PLANNING BOARD AGENDA

CZ-23-01 Buffalo Road: The applicant is requesting to rezone a 138.63-acre tract of land from the R-20A, R-10 and R-8 Residential zoning districts to the R-8 Conditional Zoning district with a master plan consisting of 217 single-family residential lots. The property considered for rezoning is located on the east side of Buffalo Road, approximately 300 south of its intersection with Holland Drive and further identified as Johnston County Tax ID# 14A03005.

Subject: CZ-23-01 Master Plan Comment Questions
CZ-23-01 Buffalo Road

EXAMPLE ELEVATIONS

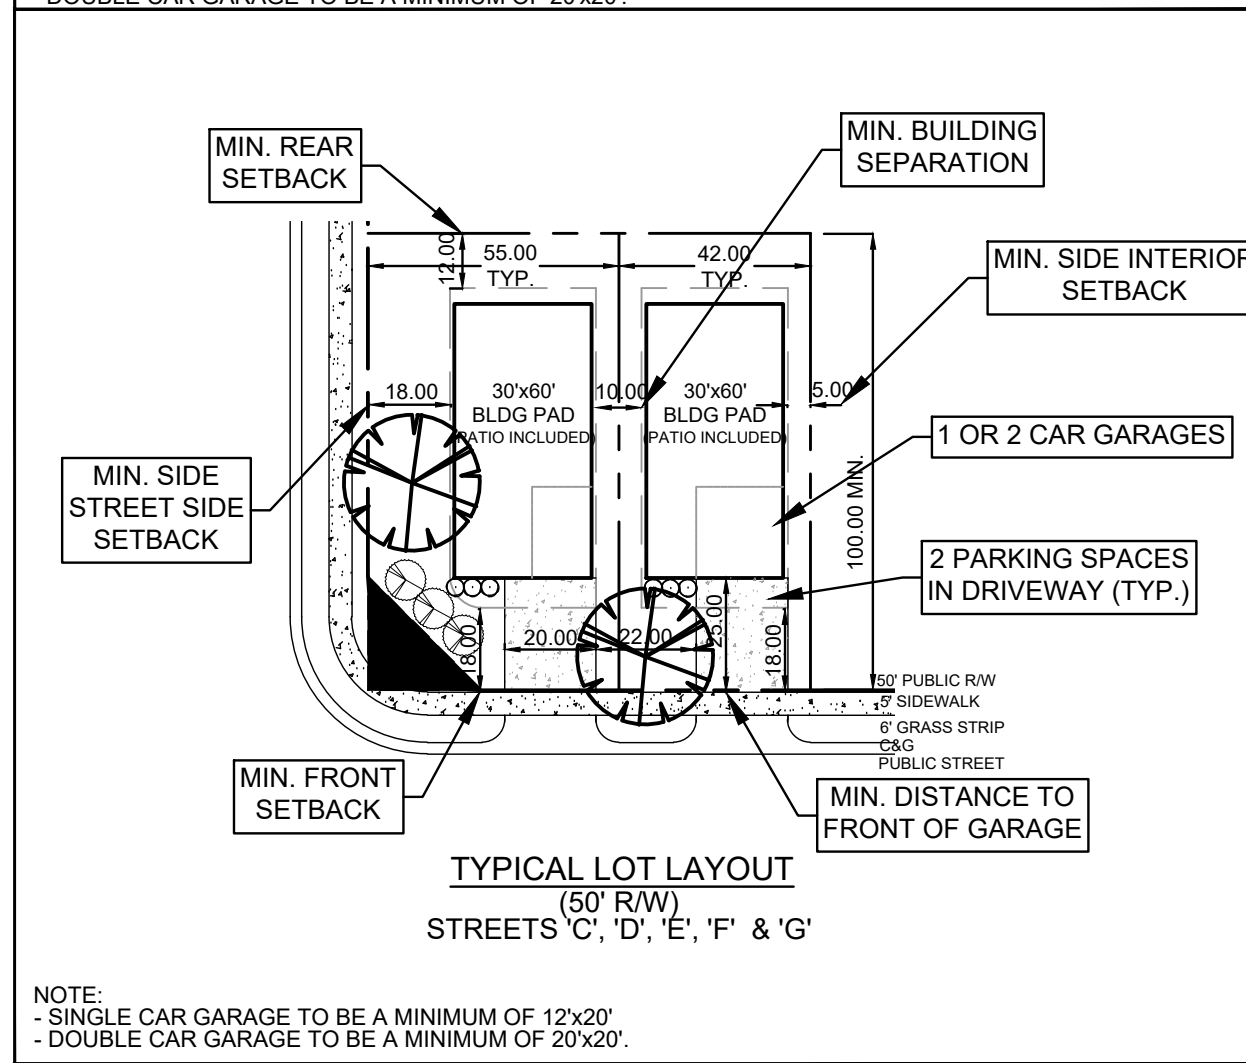
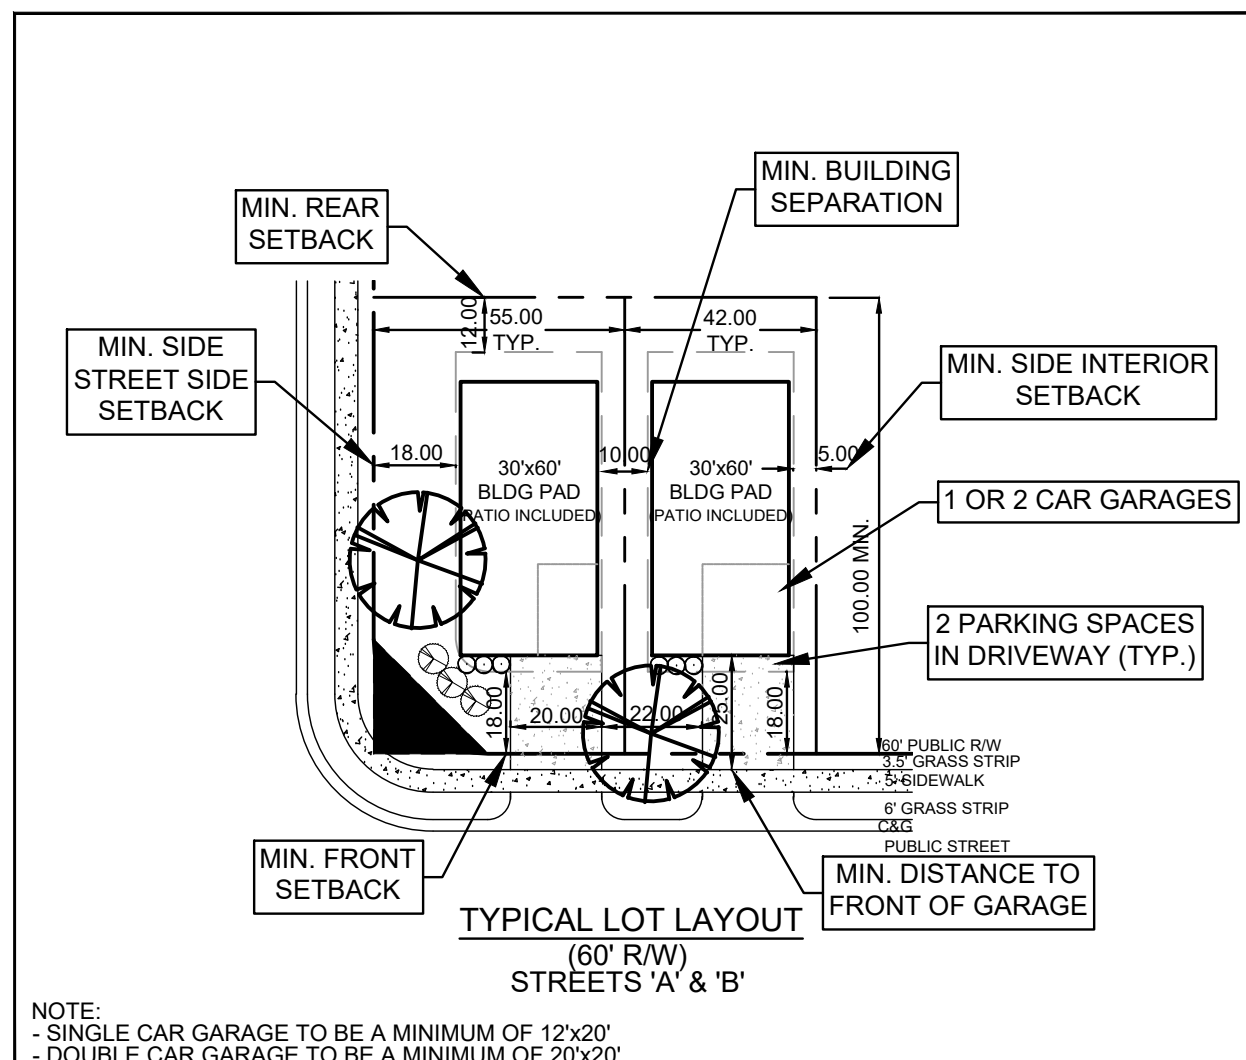
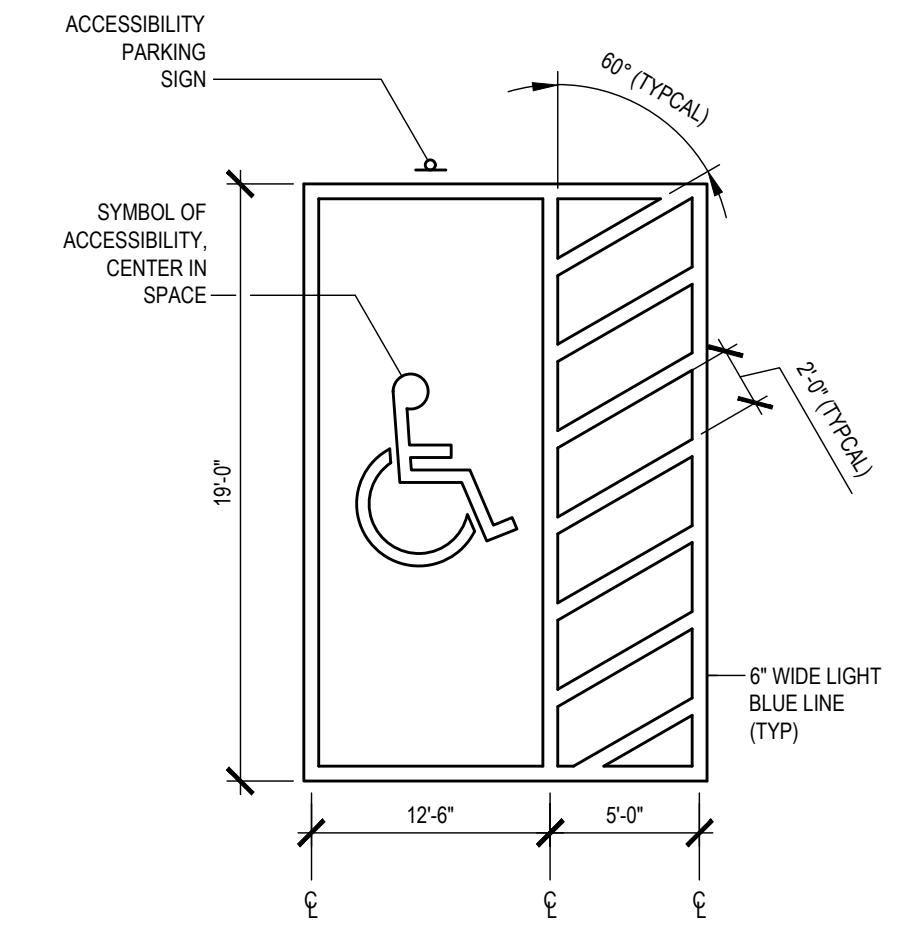
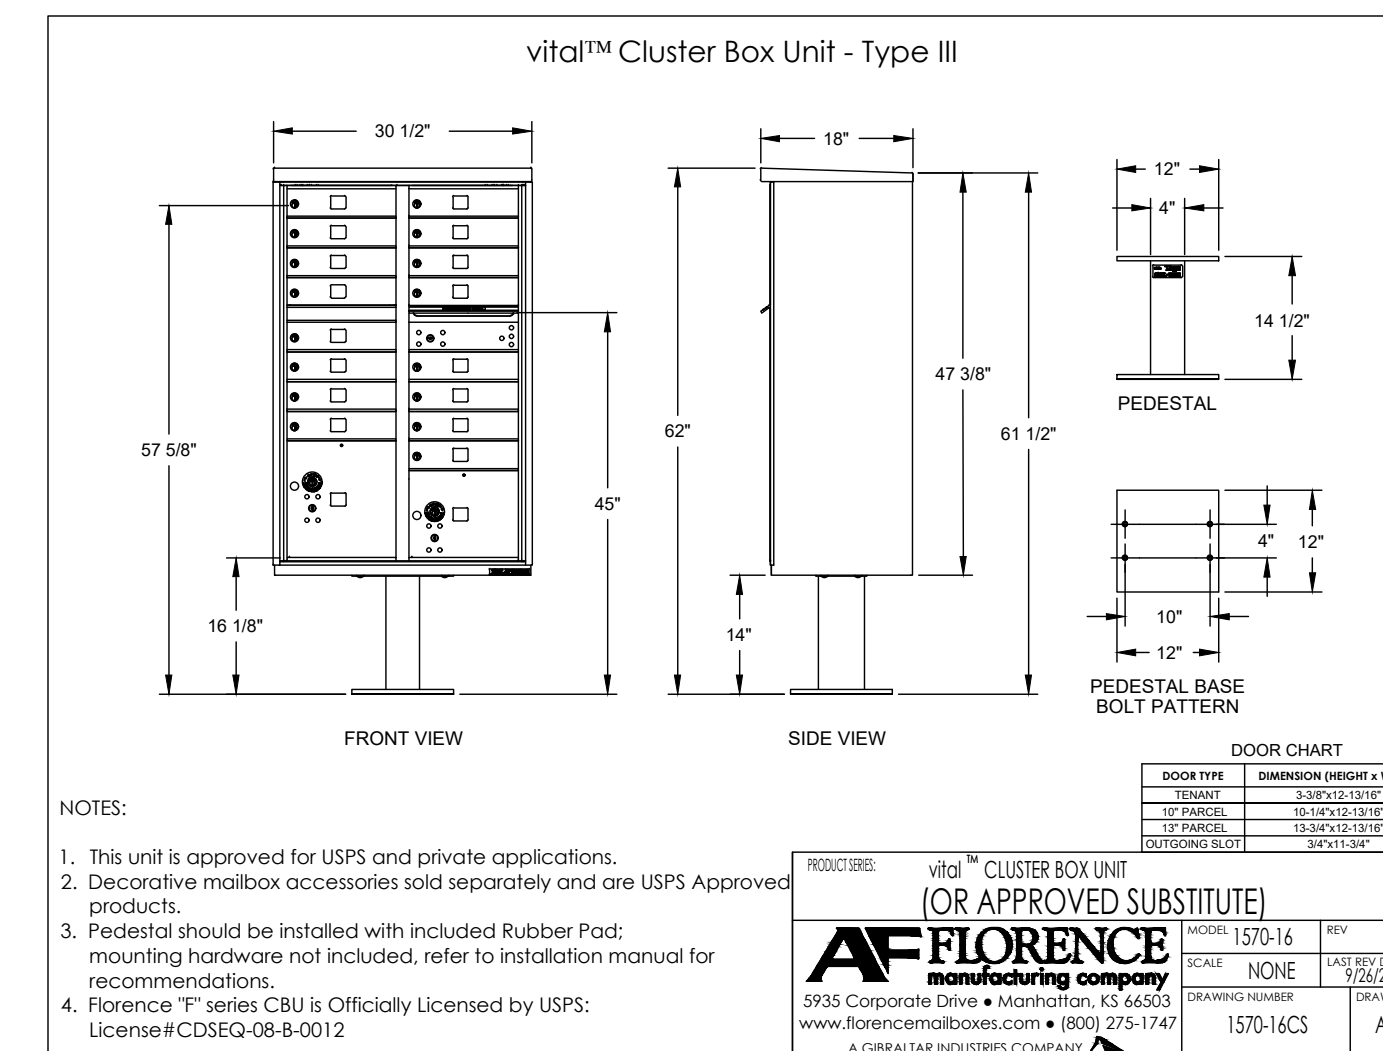
- Provide detailed architectural standards describing the example elevations provided.
- Provide traffic calming for Street A in the form of traffic circles at key intersections.
- Provide a continuous trail from the Buffalo Creek Greenway to Buffalo Road
- Provide concrete curb and gutter along Buffalo Road (piping the ditch) as allowed by NCDOT.
- Provide a minimum right-of-way width of 60 feet for all lots.
- Modify the road connection to Parkway Drive so that it is not a direct connection to Street A.
- Provide a greater variety of lot widths with larger lots adjacent to the Bradford Park neighborhood.
- Provide street and sidewalk in the lateral road connection to the south.

19. The Tot Lot should meet ADA requirements. **Removed Tot lot from project.**
20. The garages for single-family homes should be sized to accommodate vehicle parking, such that a single car garage is a minimum of 12' x 20' and a double is 20'x 20'. **Noted on sheet DT1.00.**

23. Consider decorative streetlights and street sign details. **An example of decorative streetlight is located on sheet DT1.00.**
24. Show required subdivision sign details and location **Is this a requirement or suggestion? If this is a requirement, please direct us to the code/regulation so we may address this completely. This is a suggestion. A separate sign permit application is required regardless, and the signs would need to meet the UDO. The subdivision sign requirements are in the Sign Ordinance, Article 10, Part III. Signs are required to be 10' off the public right of way. An example of subdivision sign is located on sheet DT1.00. The locations have been moved to be at least 10 ft off public right-of-way.**

25. Tot lot would be better served with direct access from the public right-of-way of street B **Removed Tot lot.**
26. Provide architectural details on the right-of-way sides of the end units. **The architectural exterior materials on the sides of the units facing right-of-way to be treated as fronts. Noted on sheet DT1.00.**

27. Show landscaping on typical lot detail to include shrubs. **Shown on sheet DT1.00**
28. Provide a lateral street connection to the MAC 2008 LLC parcel to the south. **Is this a requirement or suggestion? If this is a requirement, please direct us to the code/regulation so we may address this completely. The UDO requires lateral connections. A connection to the radio station property should also be considered. This connection might address your cul-de-sac issue. A lateral right-of-way connection has been added to the southern adjacent property.**
